Job Ref: 25255

s92 Response – Te Karaka –, LR-2026-113441-00, LV-2026-113442-00, LL-2026-113442-00 & WS-2026-113444-00

Project Te Karaka Stopbank Upgrade Project

Subject Response to Pine Hollow Family Trust submission matters relevant to road raising, access and drainage design

PROJECT		
GISBORNE DISTRICT COUNCIL		
S.H.2 R.5 R.P.406/8.50 TO R.P.416/1.83 (TE KARAKA)		
S.H.2. ROAD RAISING		
TITLE		
VEHICLE TRACKING		
WSP PROJECT NO. (SUB-PROJECT)		SHEET NO.
NZ0072338.2263 (1)		VT01
		REVISION
		A

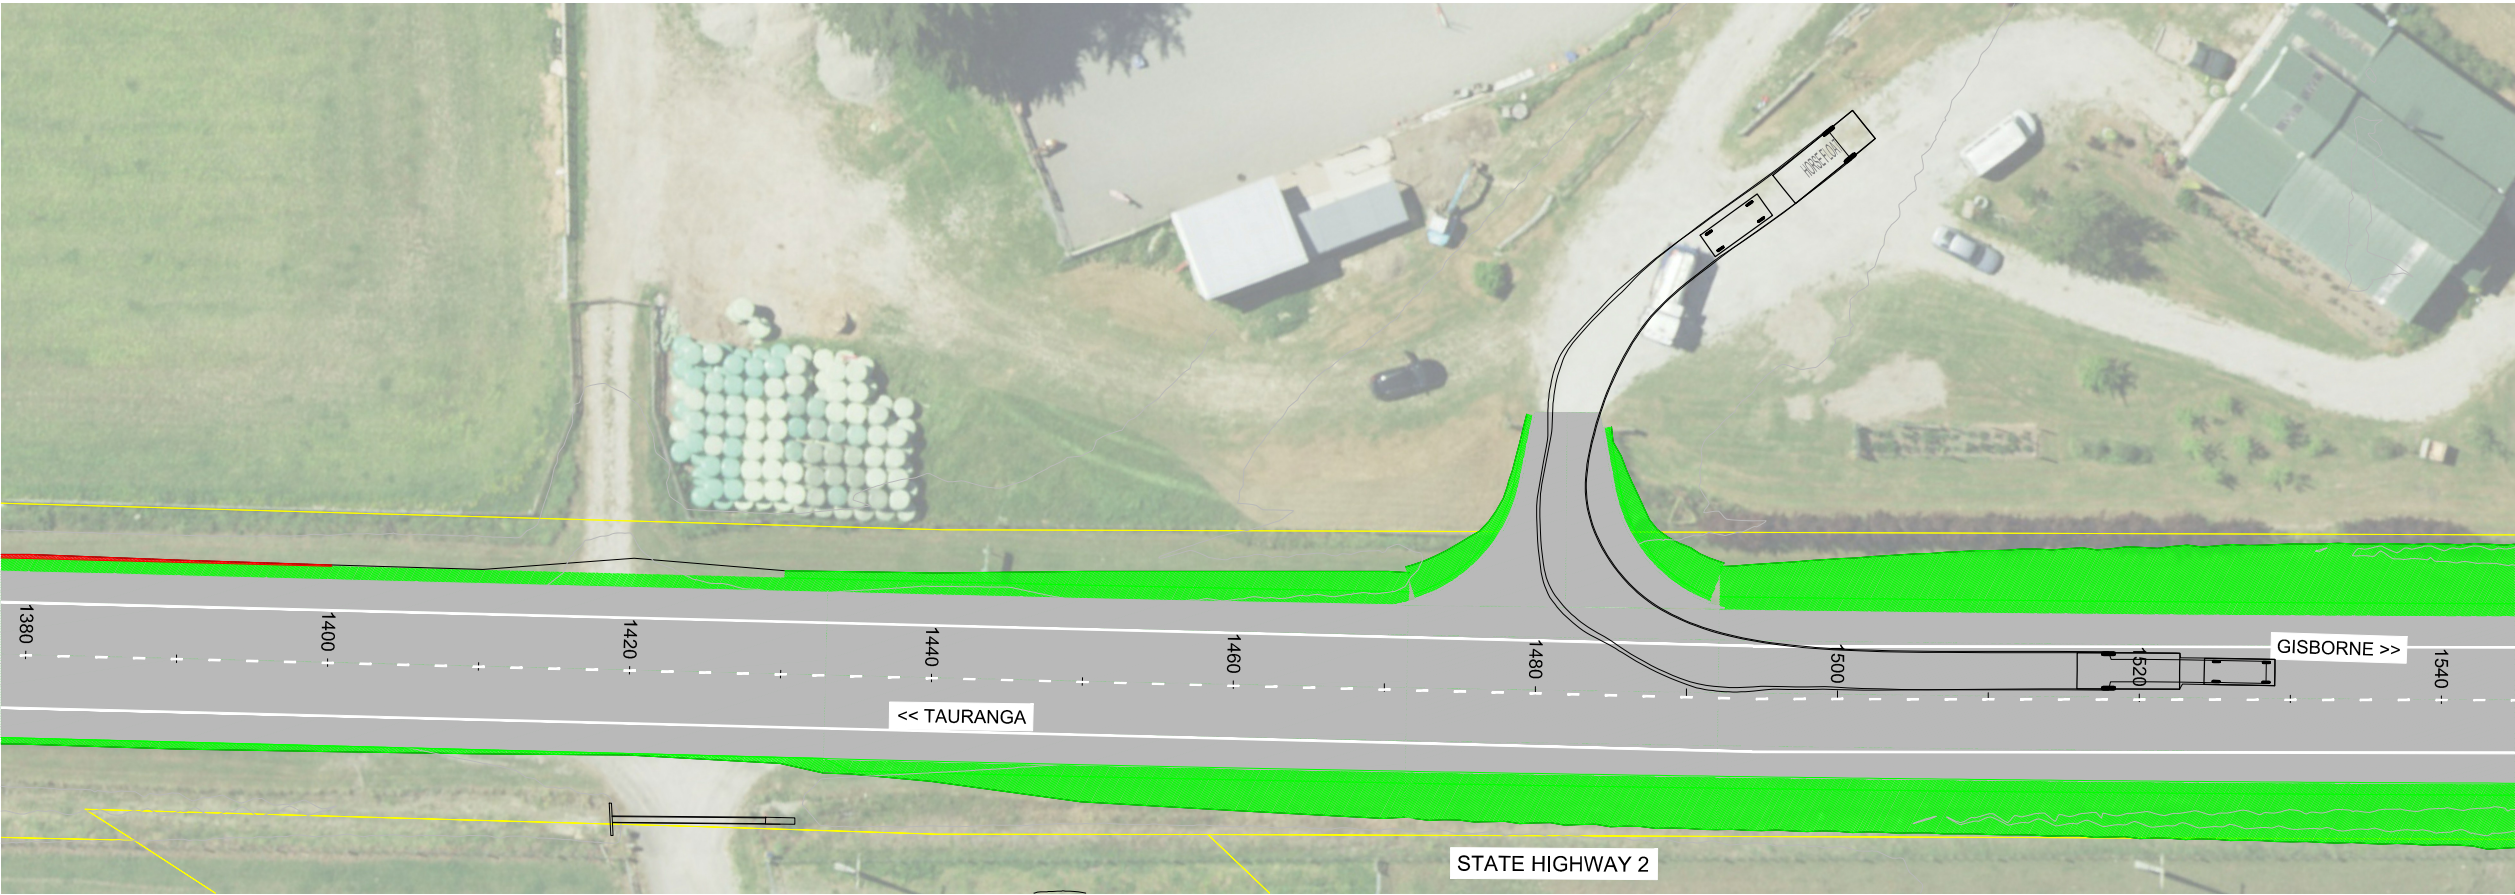
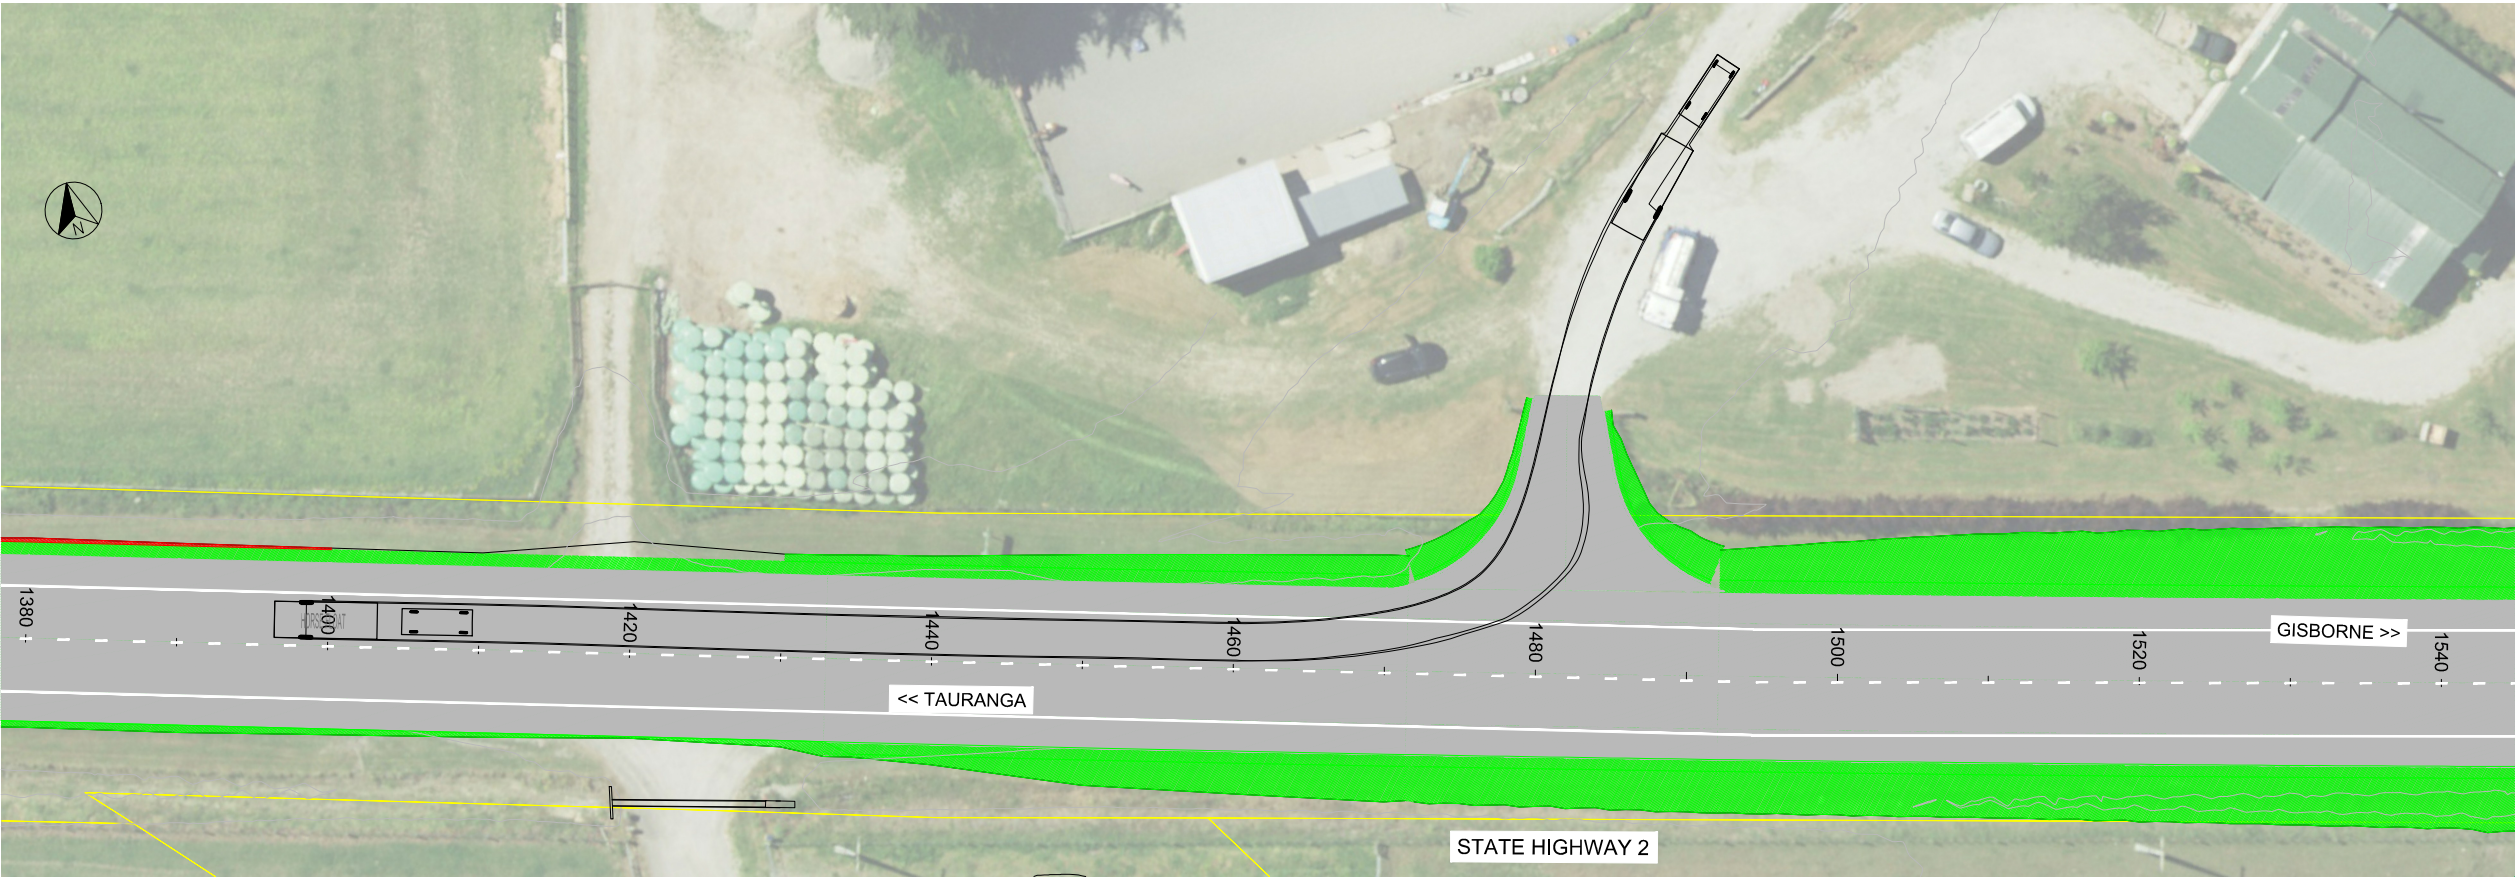
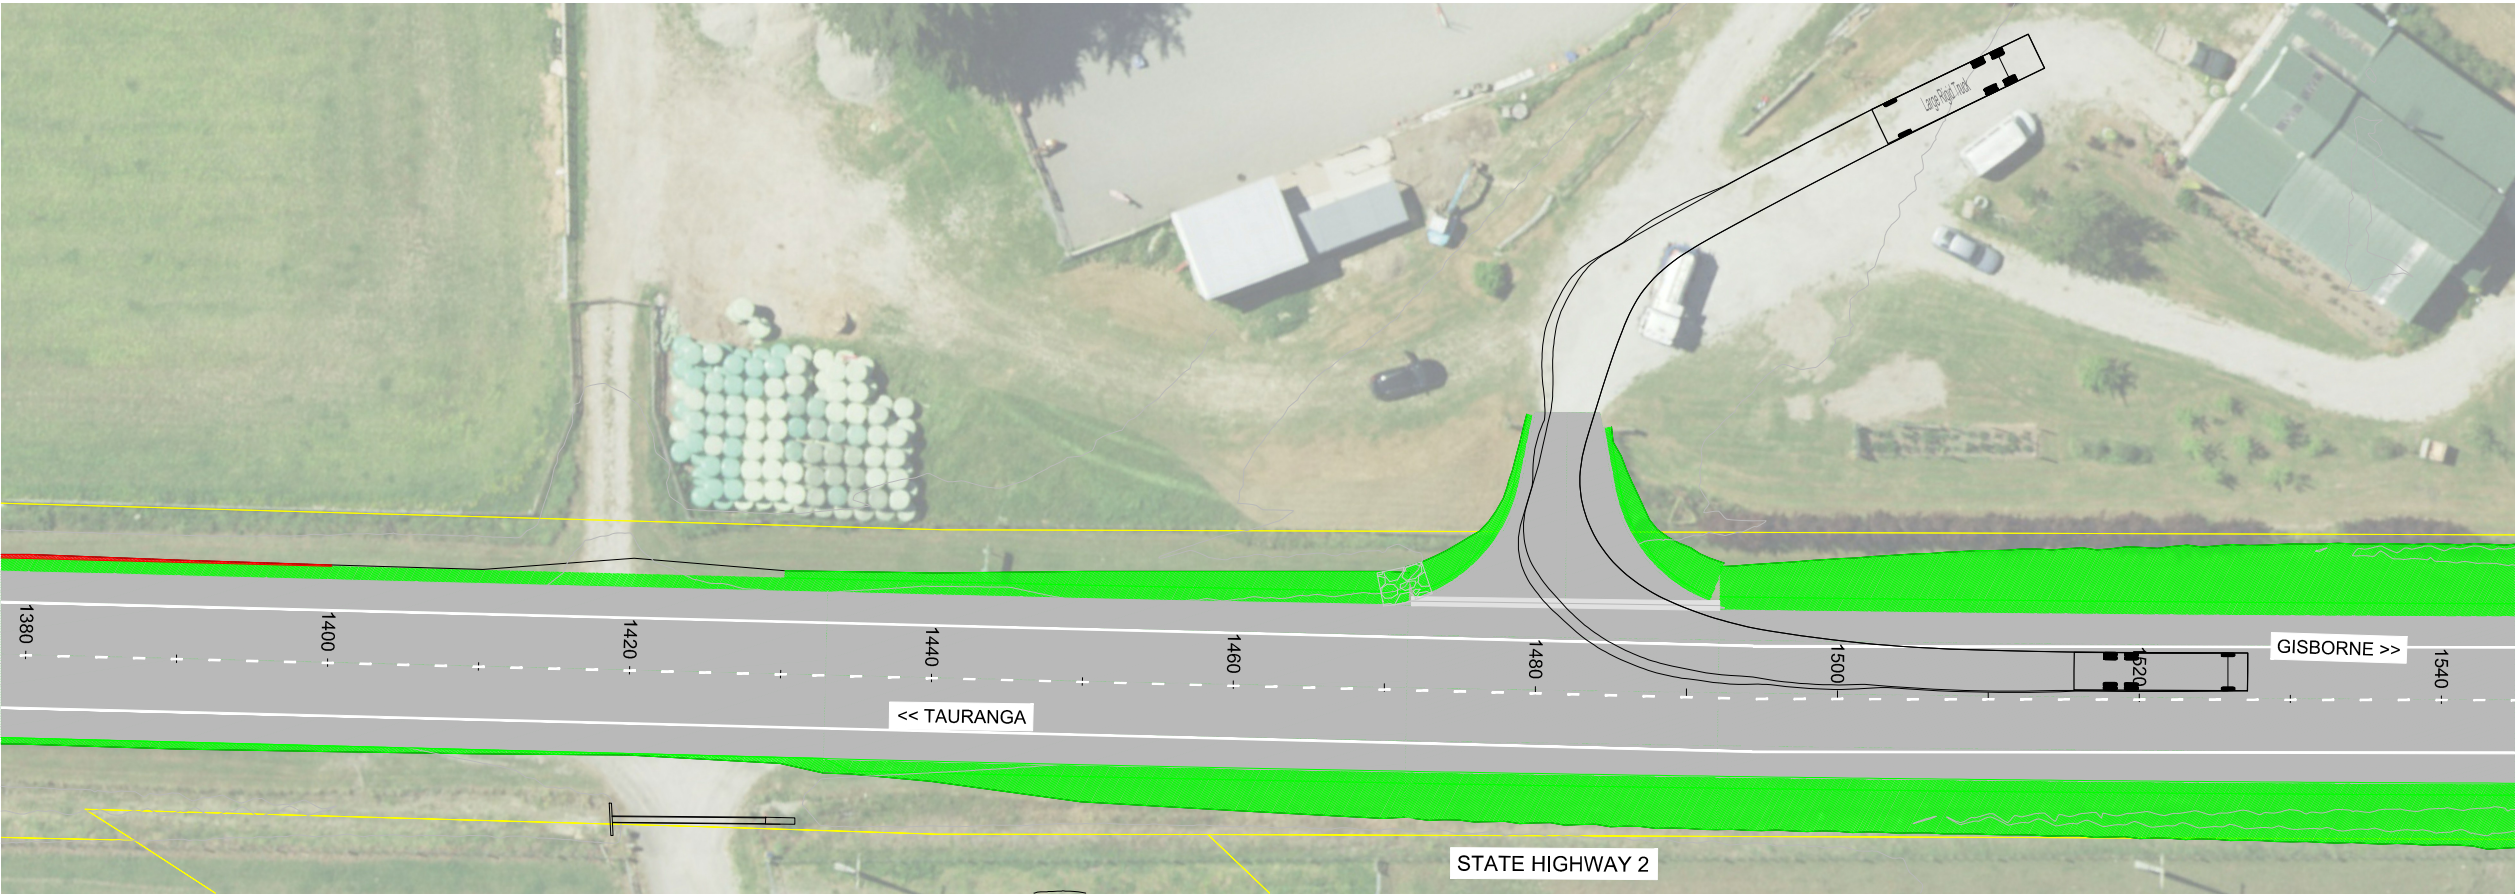
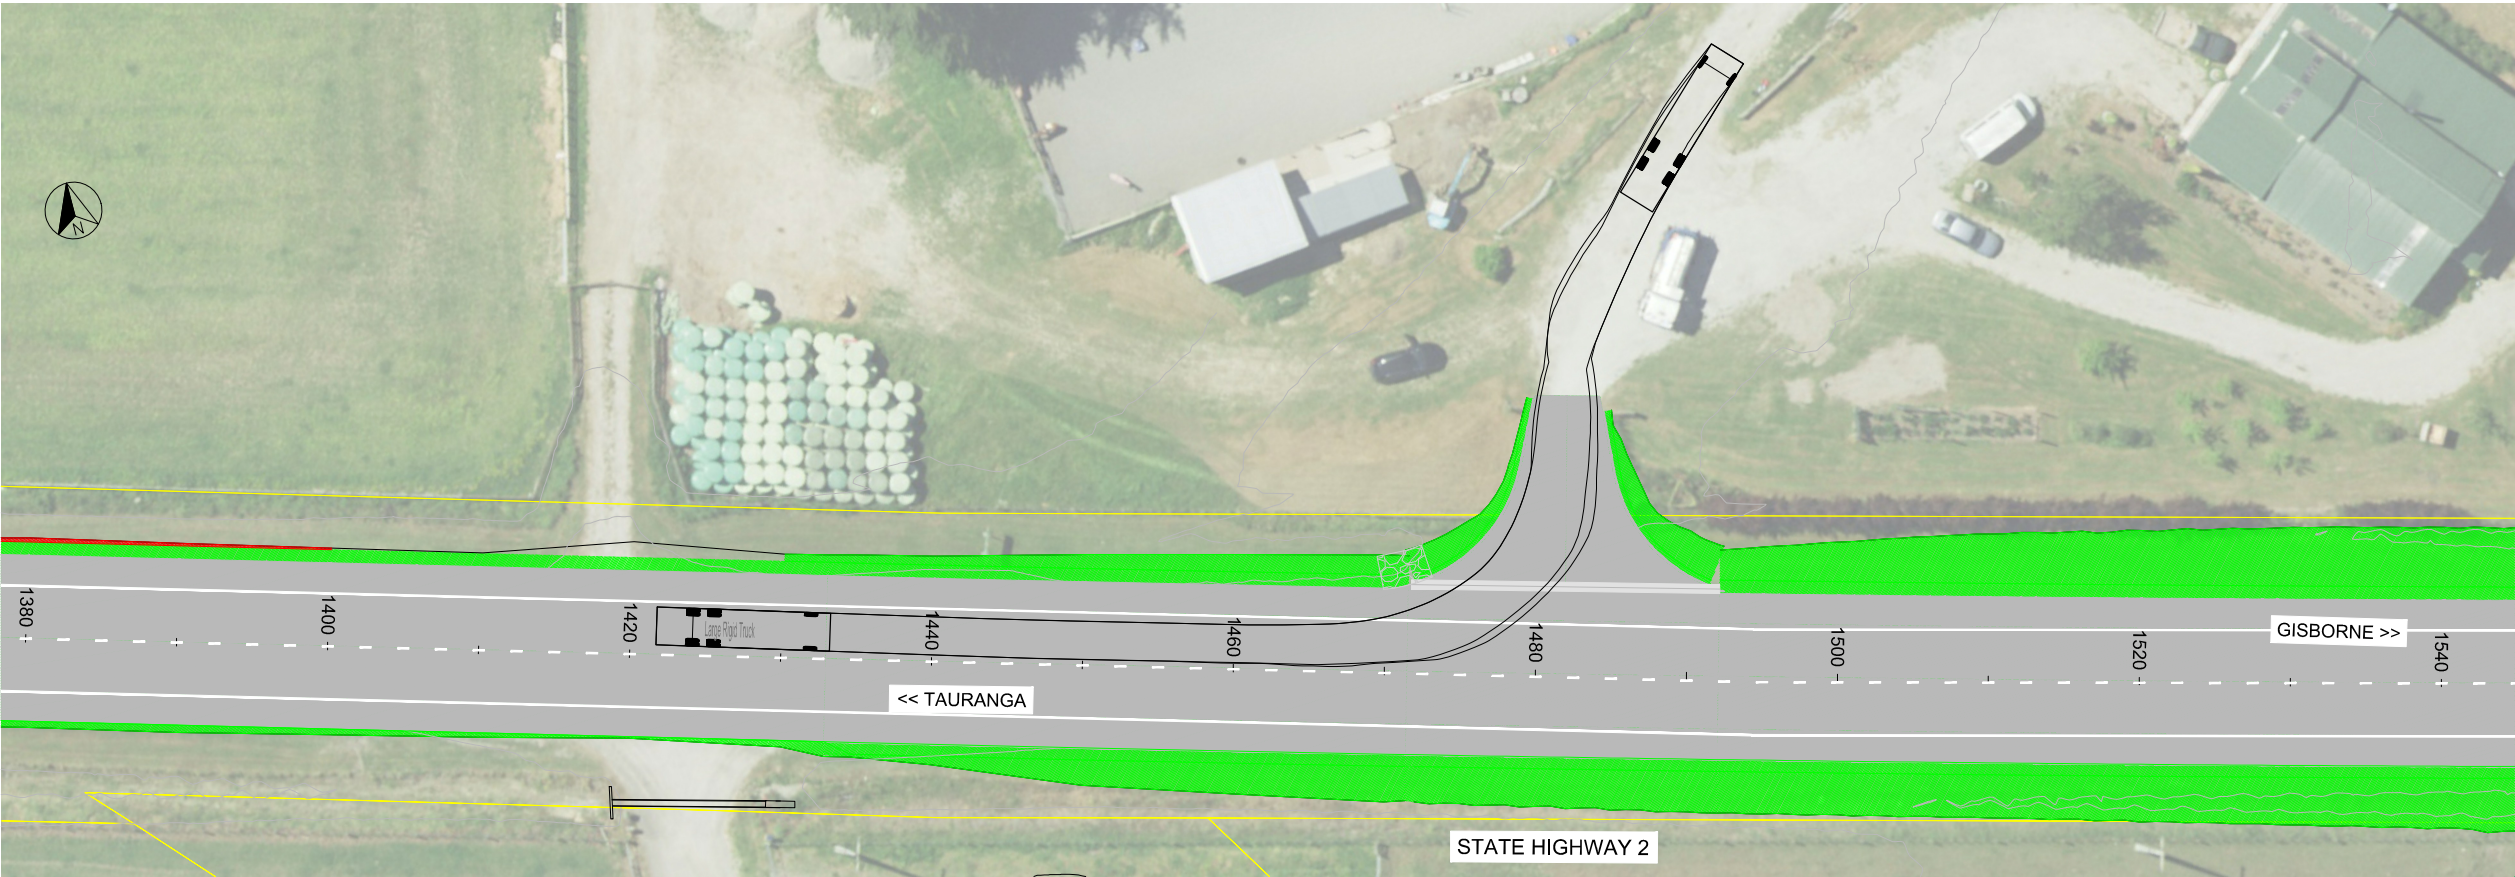
- i. *The unaddressed issue is a family in a small car waiting by the centreline to turn into the site may be obscured by the new crest from following northbound vehicles, especially cars. Similarly for a small car turning out to head north. Pine Hollow is a popular venue for young riders due to their miniature horses. (Children on miniature horses crossing the highway are similar in height to a small car.)*

Following receipt of the submission, swept-path tracking was undertaken for the Site 02 driveway using both a large rigid truck design vehicle and a smaller vehicle towing a horse float. These vehicles were selected as representative of typical horse transport movements likely to use the access. The assessment indicates that the representative vehicles can safely enter and exit the property via the proposed access arrangement. Where required, larger vehicles may use the opposing traffic lane during manoeuvring, which is typical for larger vehicles accessing rural properties from a two-lane state highway. The tracking assessment should be read alongside the sight-distance and road-safety provisions incorporated into the design. The swept path tracking is shown below in appendix A.

The assessment indicates that the representative vehicles can enter and exit the Site 02 access under the proposed design.
Sightlines when exiting the property after SH2 is raised.	Access geometry and sight distance have been considered through the design and Safety System Audit process.
Request for double yellow lines, speed reduction and a flush median near the raised SH2 section.	Road marking and signage have been updated where relevant, including no-overtaking controls where the Safety System Audit identified constrained visibility. Requests for a speed-limit change, flush median or other additional road-control measures require consideration by NZTA as the road controlling authority
Construction noise/vibration and health and safety risks to horses and riders.	Acknowledged as matters to be addressed through construction management planning, temporary traffic management and landowner liaison. These matters are separate from the permanent road design. WSP is available to discuss transport-related concerns with the submitter and project team.
